MATANUSKA-SUSITNA BOROUGH PLANNING COMMISSION AGENDA

June 6, 2022
REGULAR MEETING
6:00 p.m.

SUBJECT: 2022 Official Streets and Highways Plan Update

DOTPF TRAFFIC & SAFETY REVIEW COMMENTS
2021 DRAFT OSHP MAPPING

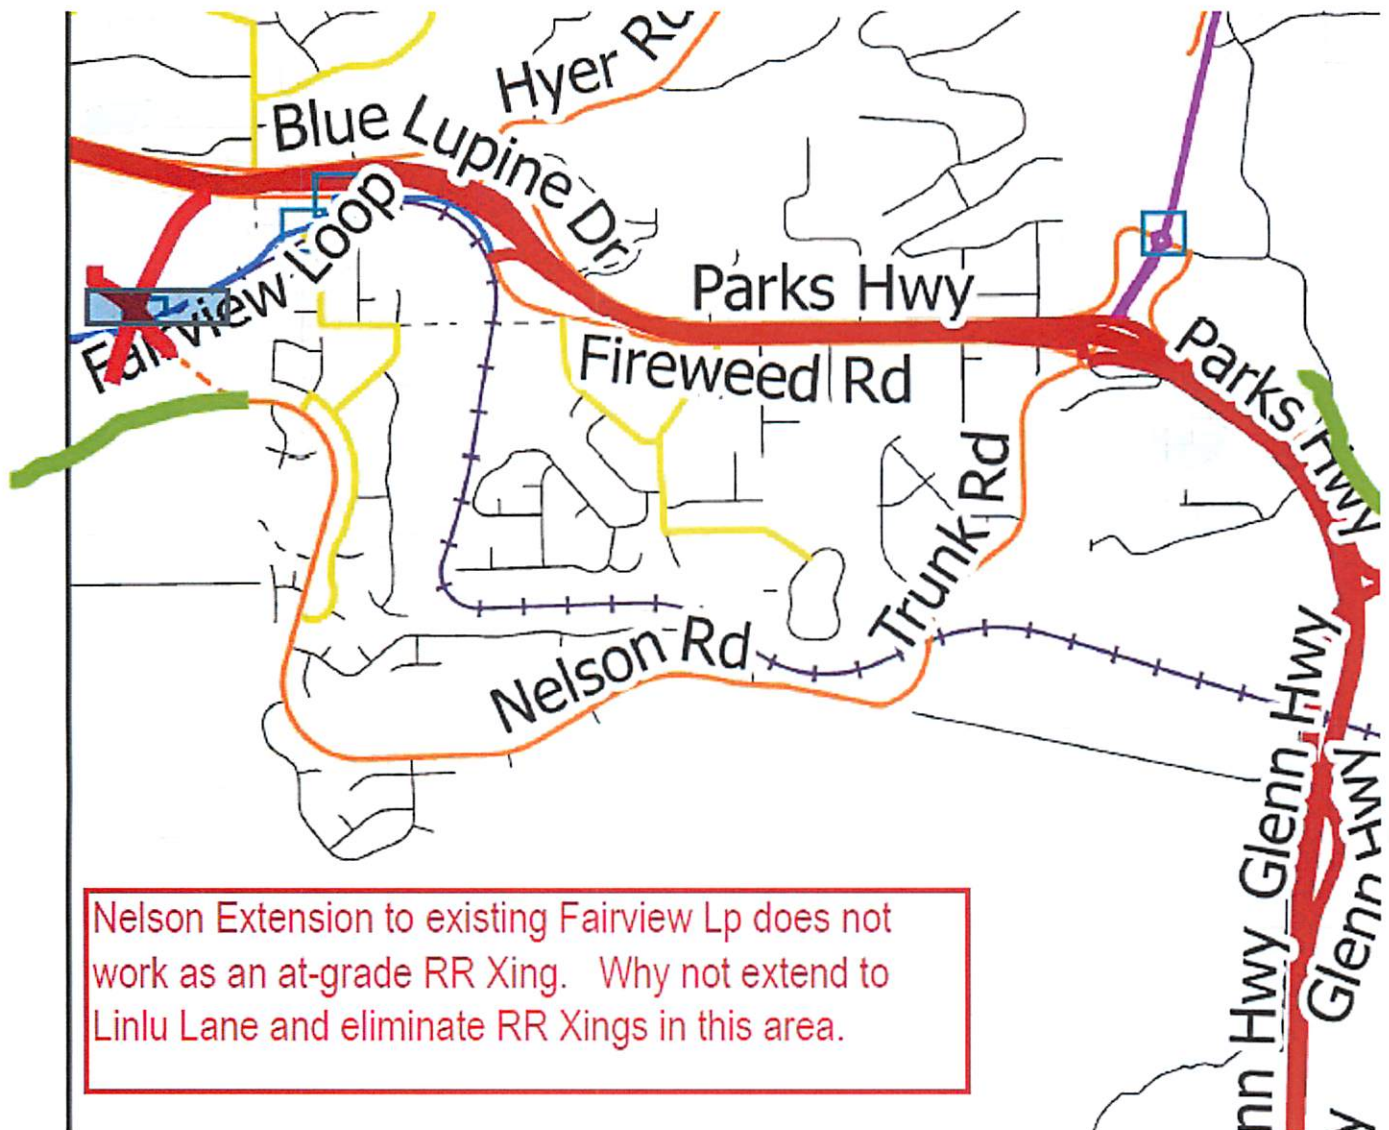
- Safer railroad crossings through proper spacing and grade separation over time with growth (like the 2nd bullet, but RR Xing intersections)

- 4) And modify bullet 4 (in red):

- The possible closure of left-turn access on and off arterial roads and interstates for safety (this is DOTPF Policy when approaching 20,000 vehicles per day.)

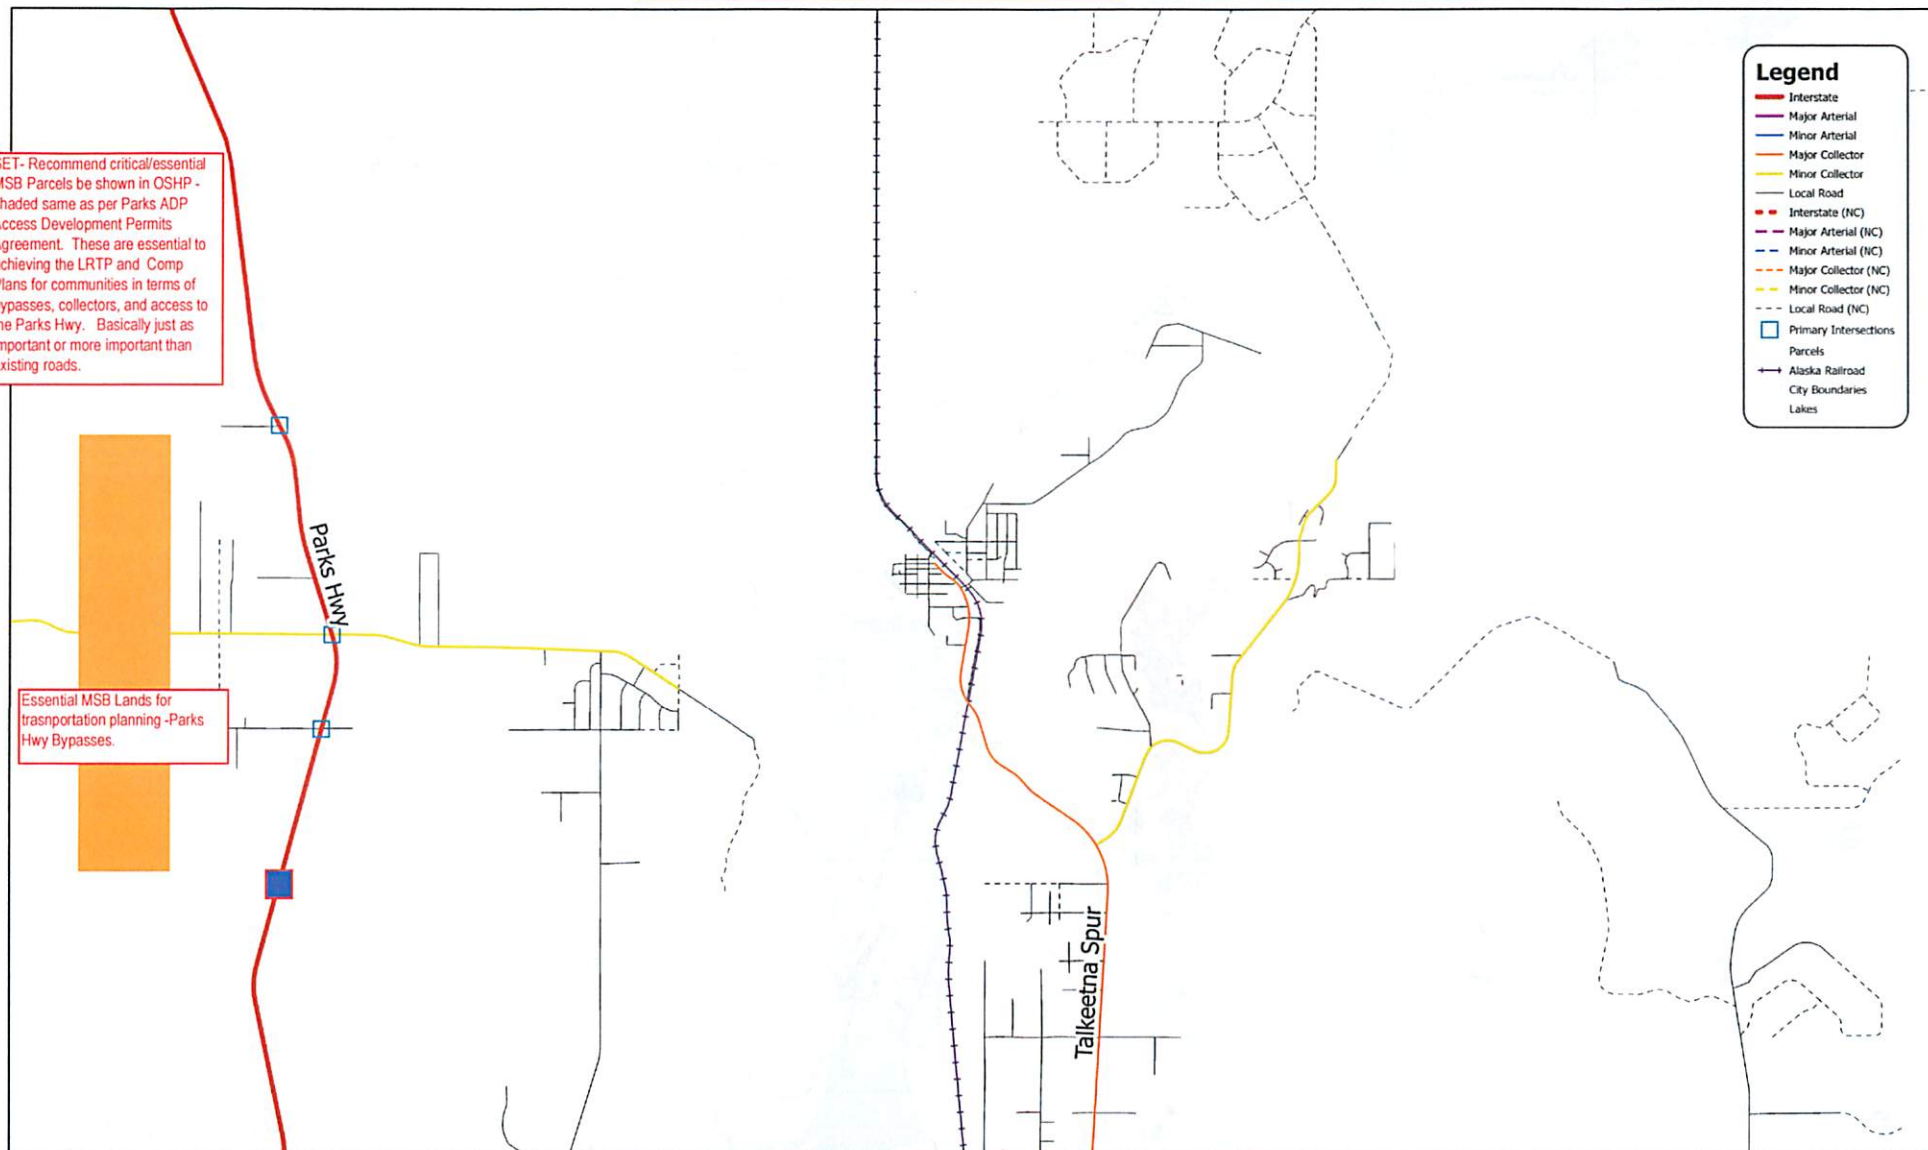
SET- Recommend critical/essential MSB Parcels be shown in OSHP - shaded same as per Parks ADP Access Development Permits Agreement. These are essential to achieving the LRTP and Comp Plans for communities in terms of bypasses, collectors, and access to the Parks Hwy. Basically just as important or more important than existing roads.

Essential MSB Lands for transportation planning -Parks Hwy Bypasses.

MSB Lands - Essential to Transportation Planning (Willow Bypass)

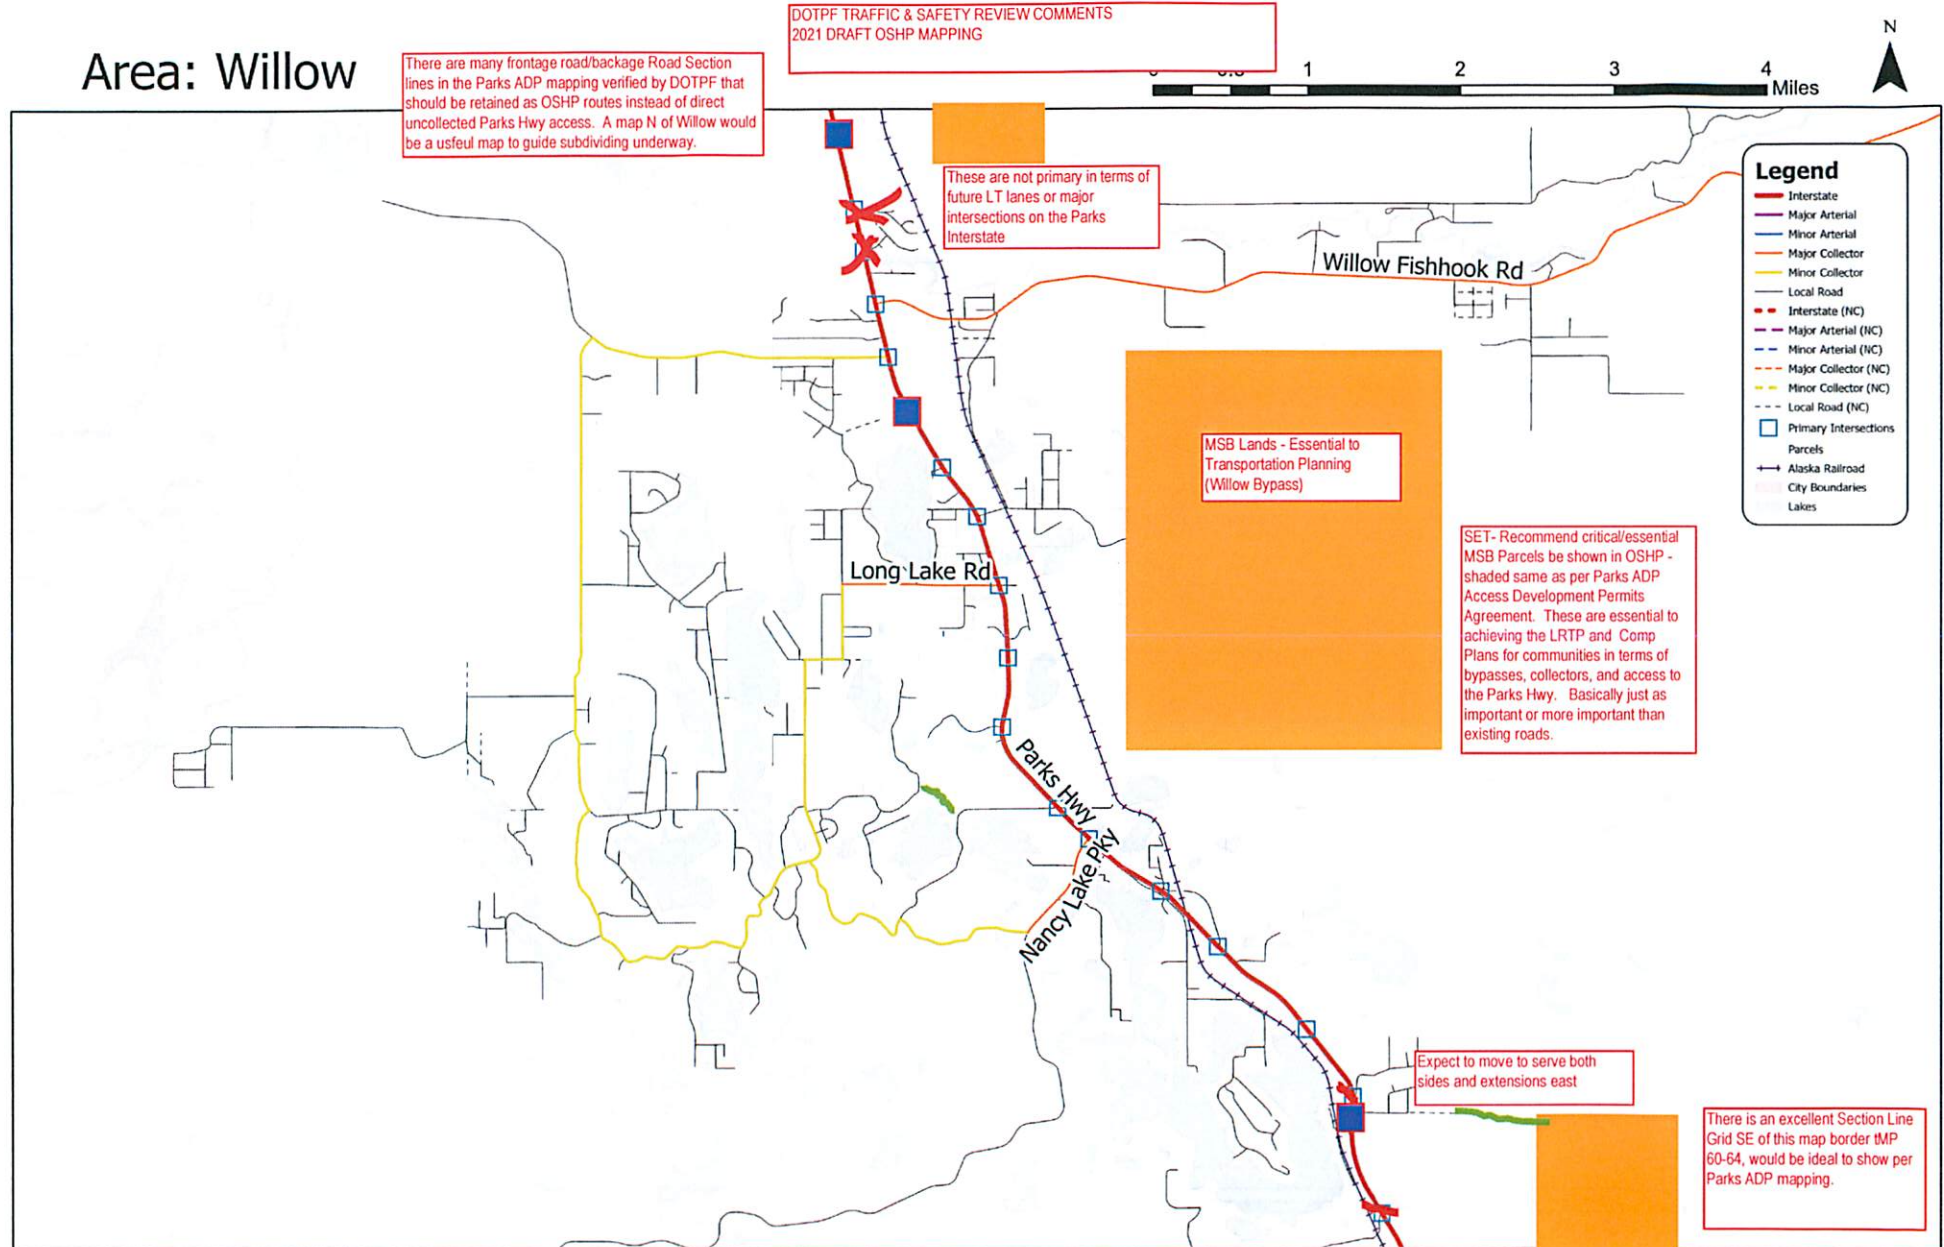
There are many frontage road/backage Road Section lines in the Parks ADP mapping verified by DOTPF that should be retained as OSHP routes instead of direct uncollected Parks Hwy access. A map N of Willow would be a useful map to guide subdividing underway.

These are not primary in terms of future LT lanes or major intersections on the Parks Interstate
